SERVICE BULLETIN

APPLICABILITY: 2010-14MY Legacy and Outback Models
SUBJECT: Design Change to Retaining Clip for Front ABS Wheel Speed Sensor

NUMBER: 06-49-15
DATE: 05/29/15

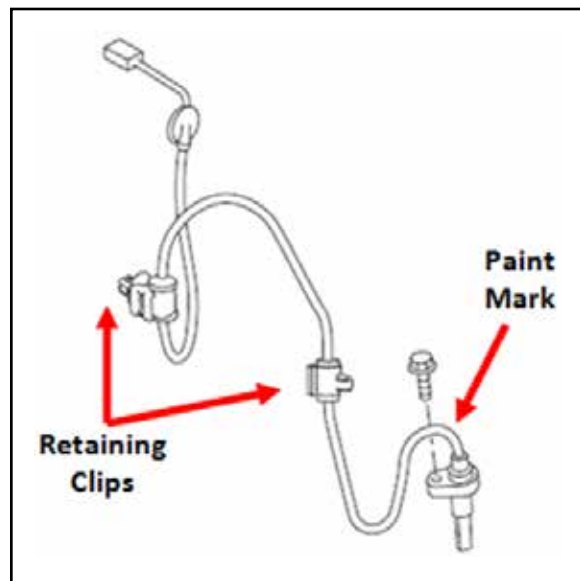
In response to isolated reports of cracked or broken ABS wheel speed sensor harness retaining clips caused by reaction with acids used in some wheel cleaners, the clip material has been changed to polypropylene (PPO).

NOTE: The paint markings are located on the harness near the sensor mounting flange end. Old parts may be recognized on the car by their Pink (Legacy) or Blue (Outback) paint marks.

PART NAME:	PART NUMBER:	NOTE:
SEN SUB AY FT (Legacy)	27540AJ12A	GOLD Paint Mark
SEN SUB AY FT (Outback)	27540AJ13A	GREEN Paint Mark
